UNC Draft Responses to USNRC Group 2 RAI Clarification Comments
March 2, 2020

Technical questions (labeled as Q) pertaining to the Group 2 RAI Responses - 1st submittal dated October 14, 2019

Predicted Water Retention Curve and Data Points

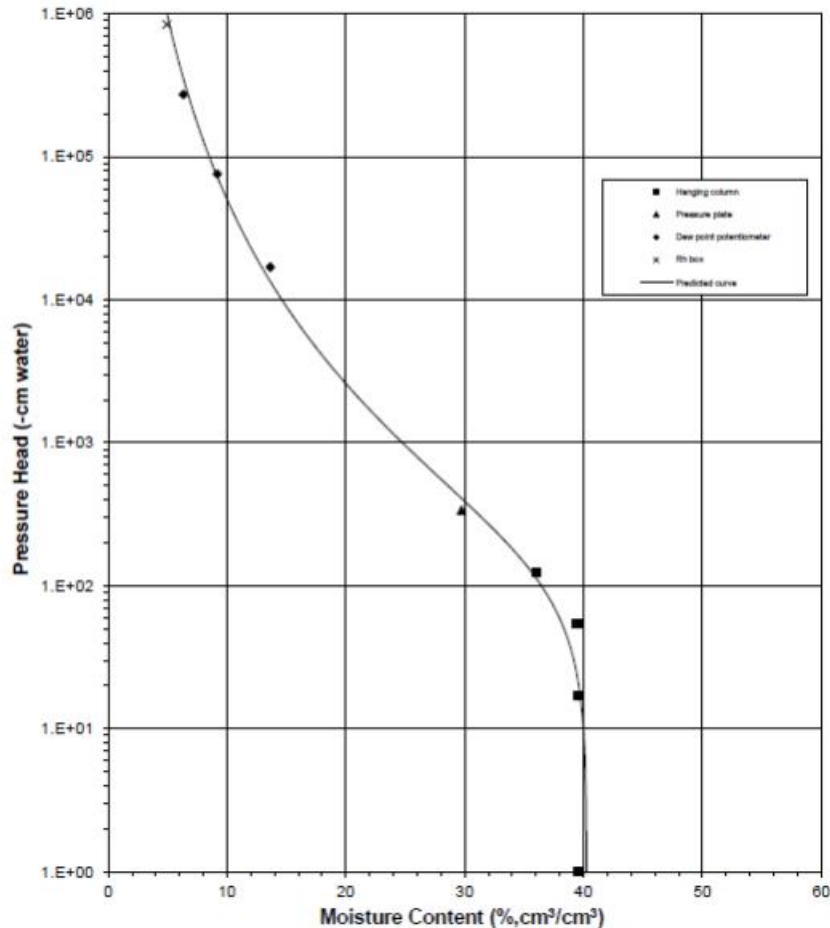
Q What is, or explain, the user-defined matric potential limit?

Response: A requirement of the UNSAT H software is defining the maximum head value (soil suction) soil can dry to. This value was defined as 1E06 cm for these simulations. If you recall the shape of a typical fine-grained soil moisture characteristic curve, as the soil moisture content approaches the residual moisture content, soil suction moves vertically up. This limits how high this vertical movement can go.

Example of a moisture characteristic curve from potential cover soil tested. It can be seen from the following graph that an assumption of 1e06 cm is conservative since the residual moisture content has not quite been reached at this head value.

- **Page 15: RAI 3.8-7 Response on figure provided with e)**

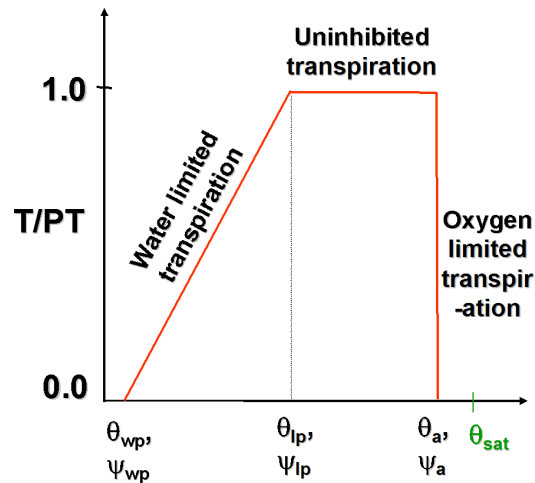
Q Where is the upward gradient to the surface after 2023? The figure shows drier conditions a foot below the surface and wetter conditions at the surface.

Q Isn't the surface (i.e., soil & rock admixture) too wet, i.e., above the wilting point, to have soil water evaporate?

Q Why is the soil suction at the surface held constant?

Q If the fine-grained tailings were saturated for decades, why do they suddenly become drier in the three years after the model starts running (i.e., 2000 to 2003)?

Response: *Not sure what you are asking. The chart shows suction values at designated depths (middle or base) of the applicable soil layer. The red is the base of the mine spoils, the green is the middle of the radon barrier/liner (the soil that is to be left in place from the existing cover), and the blue is the middle of the ET Cover. The ET Cover mid-point is 2-ft below the surface.*

Response: *The surface can't be too wet to evaporate. The wetter the surface the more evaporation. The wilting point is related to transpiration, not evaporation.*

Response: *It is not held constant. It varies depending on whether there is precipitation and thus infiltration and subsequent drying. It is not allowed to get drier or have a higher soil suction value than 1E06 cm as described in reply to **Page 6: RAI 3.8-2 Response on evaporation above.***

Response: *It is not sudden. The graph shows only the year end values at the end of the three years. Keep in mind that the graph showing soil suction is in logarithmic scale and that the suction values for the tailings are still very wet (near saturation) and mostly still in anaerobic conditions.*
